Product Change Notification / MFOL-27WRTQ128

CCB 4913 Final Notice: Qualification of 68x94 mils lead frame paddle size for selected SMSC EMC2302, MCP1641xx, MCP47CMBxx, MCP48CMBxx and MCP7384xx device families available in 10L MSOP (3x3mm) package assembled at NSEB assembly site.

CCB 4913
Pre and Post Change Summary
PCN #: MFOL-27WRTQ128

Pre Change

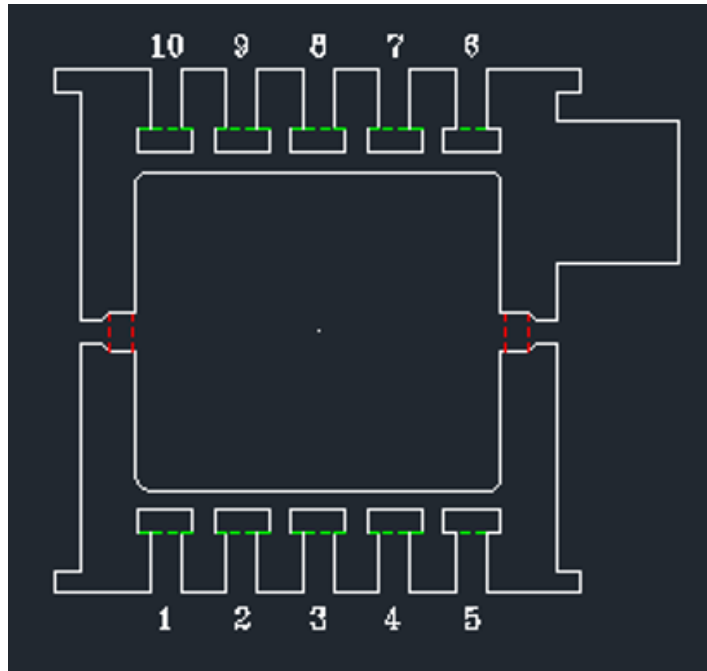
Paddle Size	82x94 mil
Lead-lock	No

Post Change

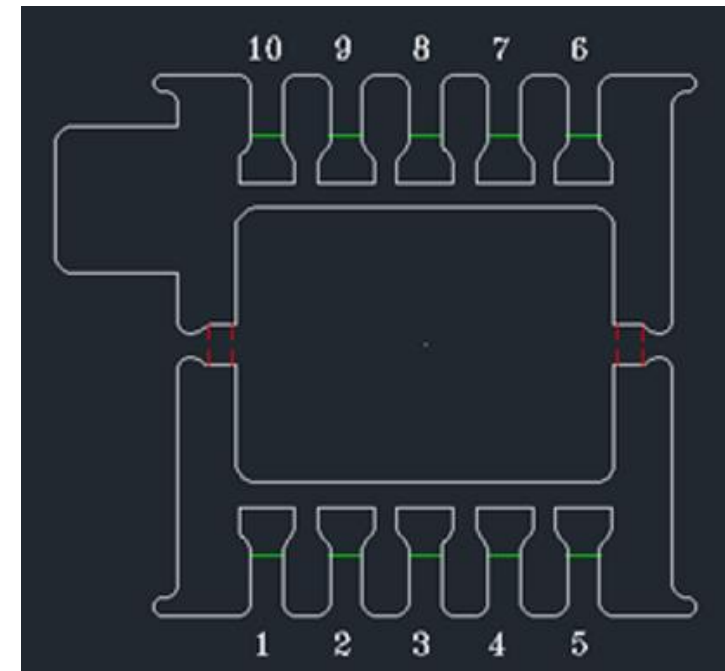
Paddle Size	68x94 mil
Lead-lock	Yes

Note: Mold compound material fills the leadlock hole, which provides improved protection against moisture penetration along the edge of the leads (pins) of the package.
